# TOWN OF MILFORD, NH OFFICE OF COMMUNITY DEVELOPMENT

**Date:** April 17, 2019

Subject: SP2019-03 Family Dental Care of Milford for the property located at Map 19, Lots 13 and 14.

Re: Interdepartmental Review Map19 Lot 13&14 Family Dental Care Facility Expansion

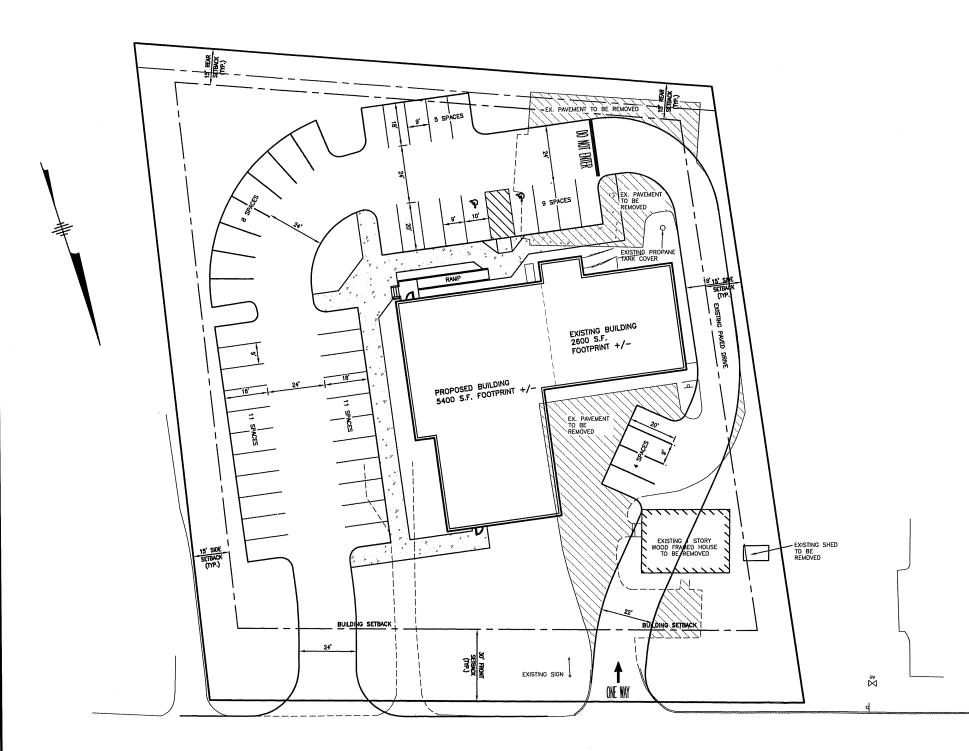
The Conservation Commission reviewed this plan at their April 11, 2019 meeting. The Commission members have comments.

- 1. We understand that this is a conceptual plan. As such, we can't comment thoroughly without more information:
  - a. Where is snow storage to be located?
  - b. Is there wet land on the backside of the property? Will a wetland delineation be required?
  - c. Will there need to be a stormwater management plan created? There will be site disturbance and an increase in impervious surface on these lots.
  - d. If a site visit is arranged, the MCC members would like to attend.
- 2. The MCC requests that native species be used in the landscaping designs. There are species that can be used that will enable the landowner to have a wildlife friendly habitat in addition to a thriving business appearance.
